**RE : WENTWORTHVILLE CENTRE PLANNING AND PLACE MARKING STRATEGY
RESPONSE TO TfNSW COMMENTS**

Bitzios Consulting has been commissioned by Holroyd Council to respond to feedback provided by TfNSW on the Wentworthville Town Centre Traffic and Transport Strategy report. This letter provides our responses to the relevant items raised. In addition, a second "Part" has been added to the Traffic and Transport Strategy report to update the traffic modelling, key findings and concept plans for the traffic and transport proposal in the centre, in response to the comments raised by TfNSW.

TfNSW provided its comments in a letter received by Council on 16 February 2016. The detailed comments were attached to that letter in Tab A and relevant items in Tab A are responded to below.

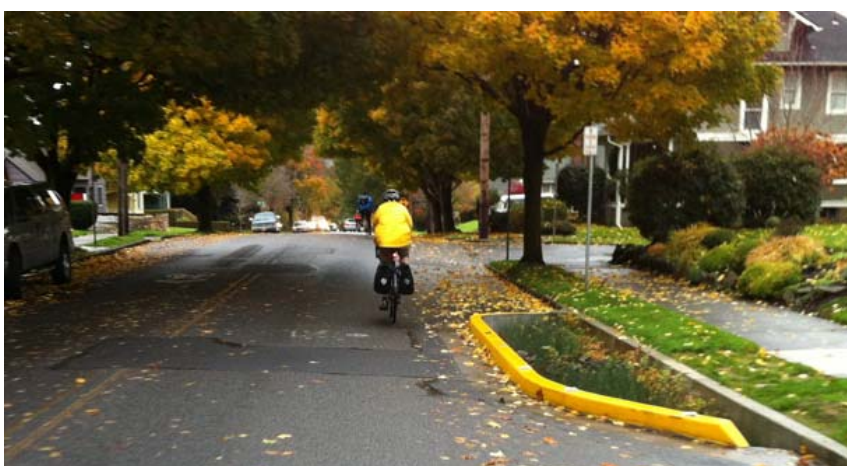
Proposed traffic calming measures on Dunmore street should be designed to minimise bus passenger discomfort. Dunmore Street is the main east-west bus corridor through the centre.

We acknowledge the need to minimise discomfort to bus passengers and expect that traffic calming measures on Dunmore Street would not be in the form of raised platforms. Rather, we would expect central medians, pedestrian refuges and kerb extensions to be used as per the examples below.

- **Central median example:** A central median will reduce the travel lane width, this will achieve a slower speed but still allow buses access with minimal discomfort to passengers.

- **Pedestrian refuge example:** Similar to a central median, a pedestrian refuge will provide a safe crossing point along the High Pedestrian Activity Area (HPAA) whilst providing traffic calming with minimal discomfort for bus passengers.

- **Kerb extensions example:** Kerb extensions provide a similar effect as a central median to constrain the driving environment to reduce speeds but involves less diversion and would provide a reduced level of discomfort for bus passengers compared to the introduction of a central median.

Figure 4.1: Turn Counts at the Proposed Signalised Intersection – Full Bypass (2031)

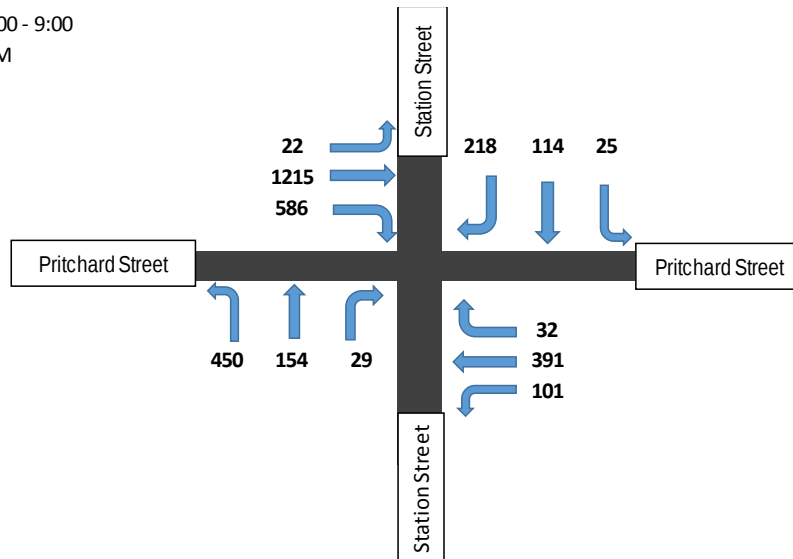
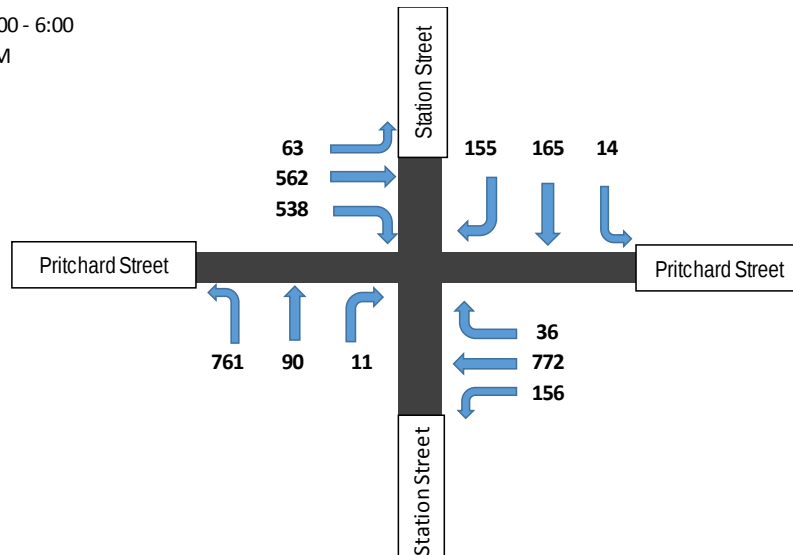
The proposed traffic signals at Station Street and Pritchard Street require approval of Roads and Maritime services under Section 87 of the Roads Act, 1993. Concern is raised that the proposed traffic signals at this intersection are located in proximity (i.e. approximately 100 metres) to the existing signalised intersection at Dunmore Street and Station Street. In accordance with industry practice (Roads and Maritime - Section 2 of the Traffic Signal Design Manual) signalised intersections should be spaced a minimum of 130 metres apart to maximise traffic efficiency and to avoid unintended and possible misinterpreted sighting of the adjacent signalised intersection.

The proposed signalised intersection will be within a highly urbanised town centre environment where drivers should be in an alerted state, sufficient to be aware of differences in signals placed appropriately 100m apart. Notwithstanding this, a warrants assessment has been completed for both the "full" and "half bypass" options as described below. Figure 4.1 shows the full bypass traffic volumes over two, two hour periods (from the Year 2031 Paramics Modelling).

Figure 4.1 outlines the full bypass traffic volume over two, two hour periods (from the year 2031 Paramics modelling).

The volumes on Pritchard Street are expected to meet the warrants for signals in 2031, whilst the volumes on Station Street (south) are lower than the 600 vph per duration (for 4 hours of the day). Given the orientation of the intersection, the heavy turning volumes and expected growth in pedestrian movements across the intersection due to land use intensification within its catchment, traffic signals would provide significant benefits for traffic safety and efficiency. The only other option for this new 4-way intersection, a roundabout, would have excessive land take requirements, would not cater overall to heavy turning movements and would be far less effective in managing pedestrian and cyclists through the intersection.

Figure 6.1: Garfield Street / Pritchard Street Swept Path Analysis

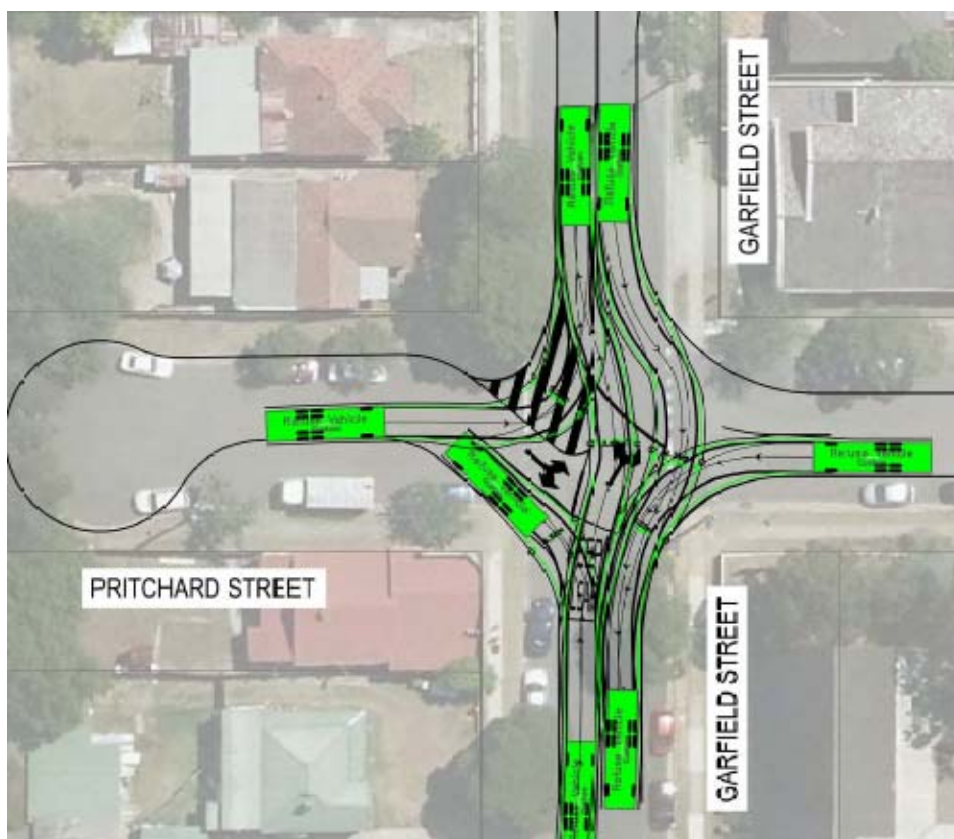
It is recommended that Council undertake a swept path analysis for all movements at the intersection of Garfield Street and Pritchard Street for the largest design vehicle to ensure that the geometry and curvature of the intersection complies with Austroads.

The proposed "Keep Clear" line marking at this intersection would need to fully conform and satisfy the criteria in the Roads and Maritime Delineation Manual Section 9.

Swept path analyses have been undertaken for the Garfield Street / Pritchard Street intersection with a Refuse Collection Vehicle (RCV) as the design vehicle. The assessment has shown that "chevron marking" is required to allow the movement of the RCV from the western end of Pritchard Street to turn north into Garfield Street, as shown in Figure 6.1. This is the only change required to this intersection concept to ensure that the design vehicle can be accommodated. Also, should the concept progress to detail design, we acknowledge that the "Keep Clear" area would need to be marked in accordance with RMS guidelines.
